**FINAL SAFETY EVALUATION BY THE OFFICE  
OF NUCLEAR REACTOR REGULATION**

**TRICONEX TOPICAL REPORT 7286-545-1,  
REVISION 4**

**INVENSYS OPERATIONS MANAGEMENT**

**PROJECT NO. 709**

**Figure 3.3.4-1 – Environmental Test Applied Temperature and Humidity Profile**

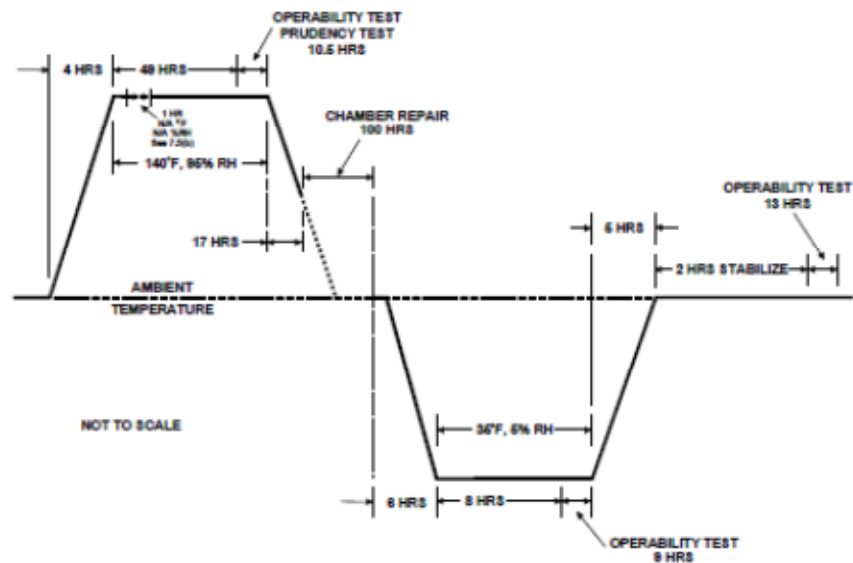
The NRC staff reviewed the "Environmental Test Report," IOM Document No. 9600164-525 (Reference 46) and determined that the Tricon V10 met the requirements of EPRI TR-107330, Sections 4.3.6 and 6.3.3, and IEEE Std 381-1977.

Figure 3.3.5-1 – OBE Test Acceleration

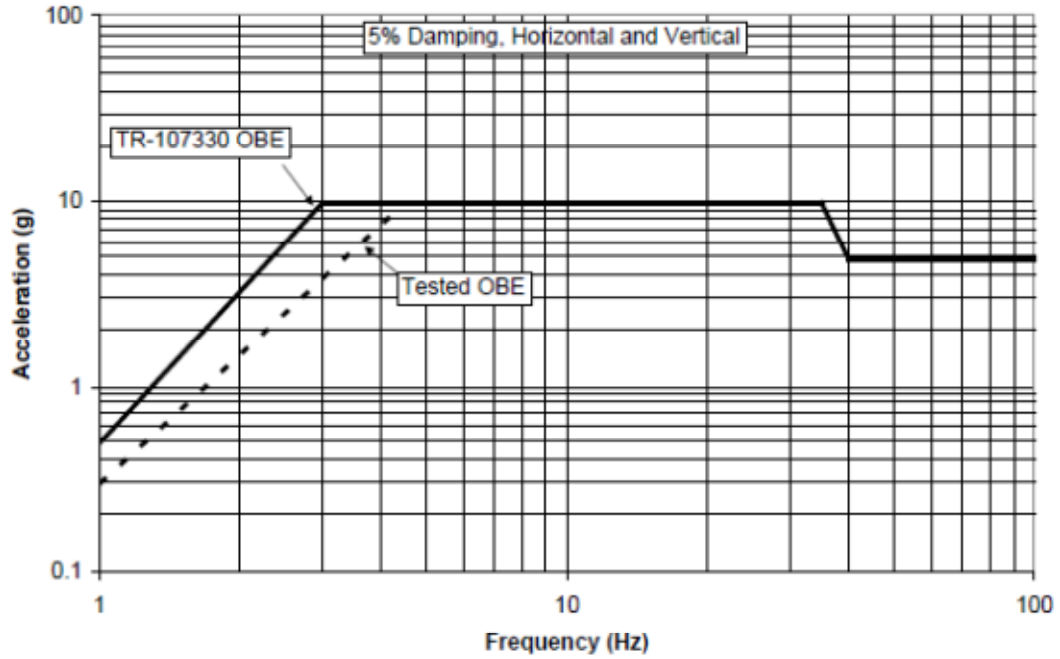
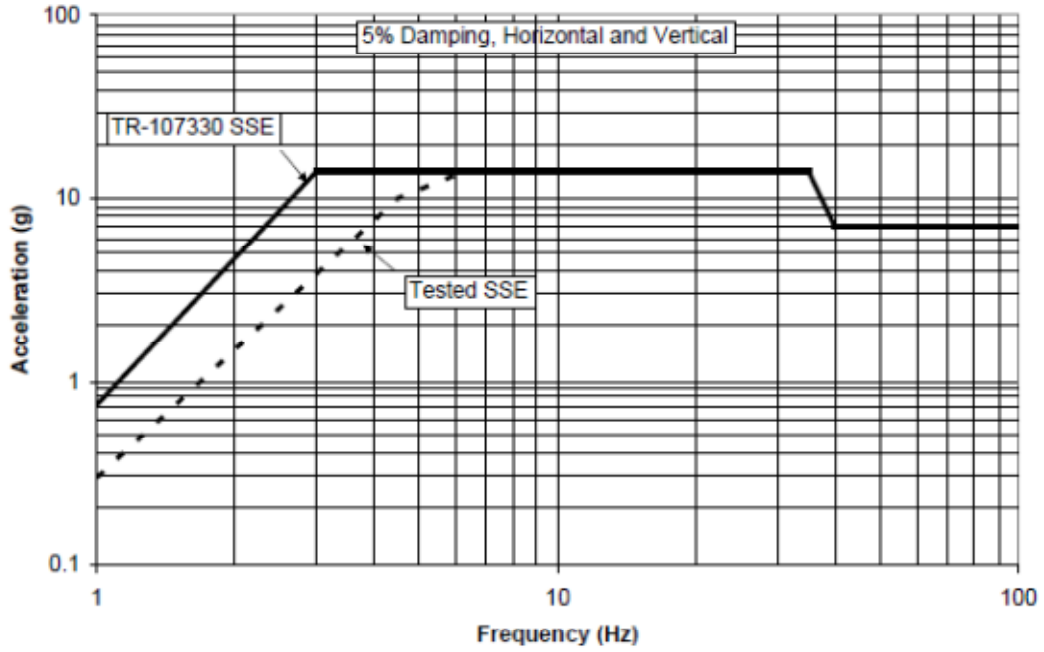
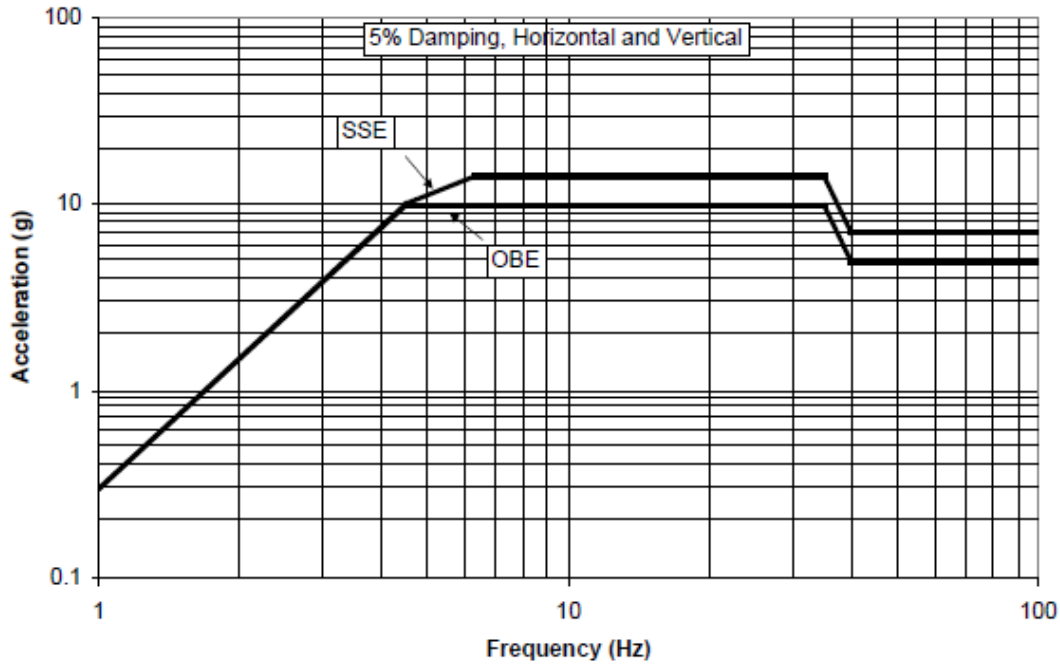
The NRC staff determined that the tested Tricon V10 system equipment is qualified to the tested triaxial seismic simulator table limits shown in Figures 3.3.5-1 through 3.3.5-3 below, with the exception of the low frequency region (below 6 Hz). For this reason the NRC staff finds that the Tricon V10 system did not fully meet the requirements of EPRI TR-107330 for seismic requirements, and before using Tricon V10 system equipment in SR systems in a NPP, licensees must determine that the plant-specific seismic requirements are enveloped by the capabilities of the Tricon V10 system. This determination and the suitability of the Tricon V10 system for a particular plant and application is the responsibility of the licensee.

Figure 3.7.2.1-1 – Safety to Non-Safety w/ MVDU via One Way Link

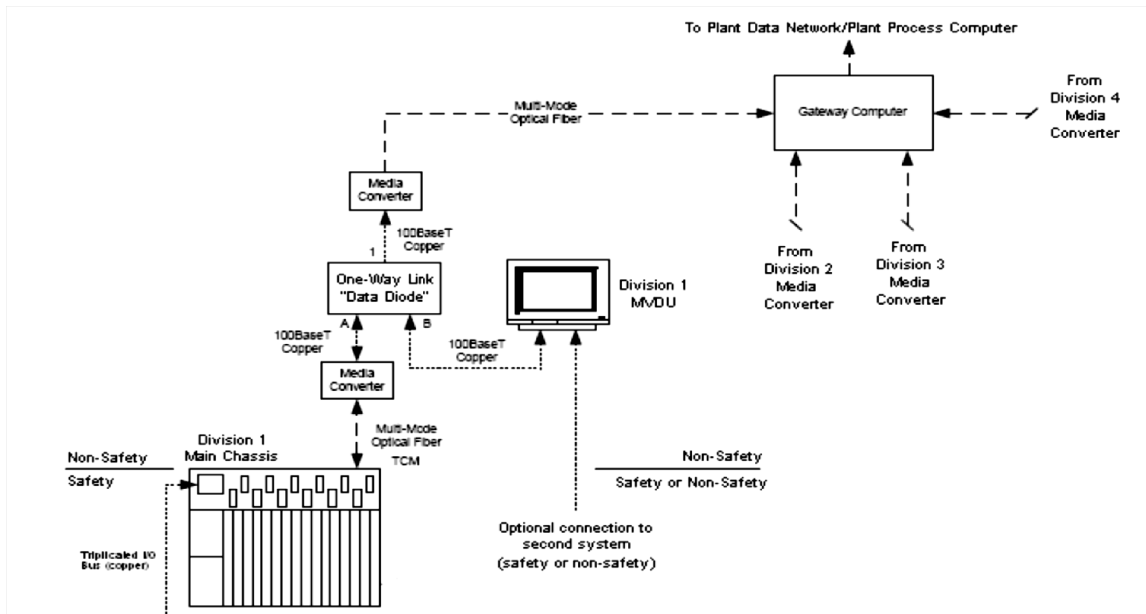
The NRC staff has determined that the data isolation function provided by the Port Tap device provides reasonable assurance that a fault or failure within the external computer system will not adversely affect the ability of a Tricon Safety System to accomplish its safety functions provided that the following ASAI's are performed.

1. Verify that the Port Tap device model number is either PA-CU, or PAD-CU. Use of any other device to accomplish this function will require additional analysis. Since the original review of part No. PAD-CU Port Tap required NRC staff examination of actual schematic drawings of the circuitry to determine that there was no inbound communications path associated with Port C, a similar schematic review for any replacement or updated model of the Port Tap must be performed to determine if the manner in which it is being used and configured are acceptable.
2. Ensure that the Port Tap device is configured in the manner illustrated in Figure 3.7.2.1-1 below.

The NRC staff determined that NSR equipment (e.g., plant computer) may be connected to the TCM through a port tap device as described above. This approval is subject to application specific review items noted above to verify the port tap device meets the precedent criteria (i.e., verify model number) and to verify port tap configuration in the system. An MVDU may be connected through the port tap as shown in Figure 3.7.2.1-1. However, approval of the MVDU will require review of plant specific procedures and review of the plant specific configuration.

**Figure 3.7.3.1.2-1 – Tricon V10 Communication Pathways**

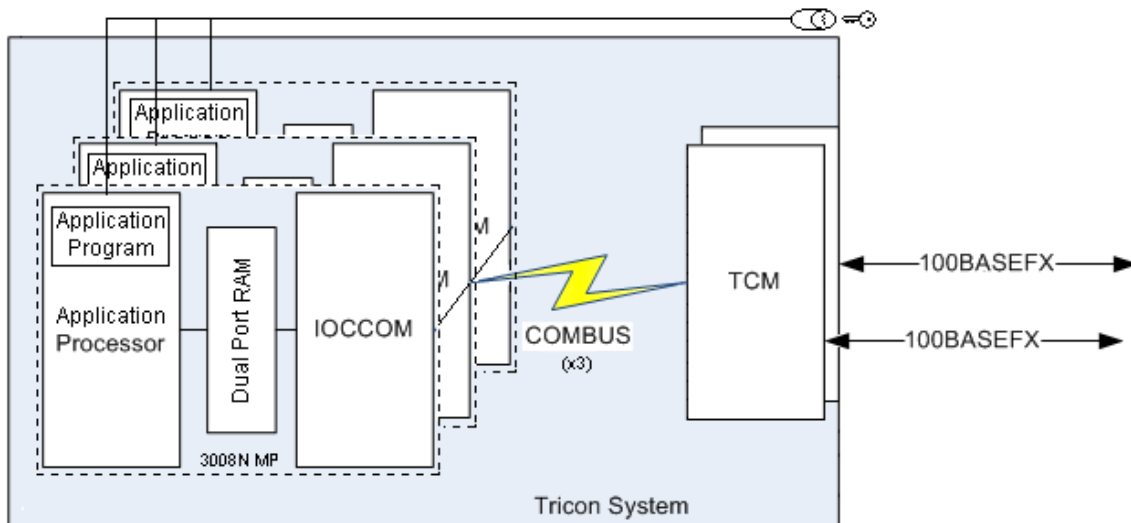
The communication path into a Tricon V10 safety channel includes the multi-mode fiber optic cable, the TCM, the triplicated Communication Bus (COMBUS), and the TMR 3008N MPs, which themselves contain the IOCCOM processor, dual-port RAM (DPRAM), and the embedded application processor that executes the control program. The TCM provides functional isolation by handling all the communications with external devices, and it has been qualified under the IOM Appendix B program for nuclear applications. The fiber optic cable prevents propagation of electrical faults into the safety processors. In addition, the TCM has been designed for high-reliability and contributes to the overall reliability of the communication link through the use of CRCs, and testing has demonstrated that it will protect the safety core from network storms and other communication failures. Upon total loss of all TCMs, the safety core will continue to function and execute the application program. Furthermore, the Tricon V10 system has been tested by Wurdtech and it has been shown to be resilient against the communication faults.
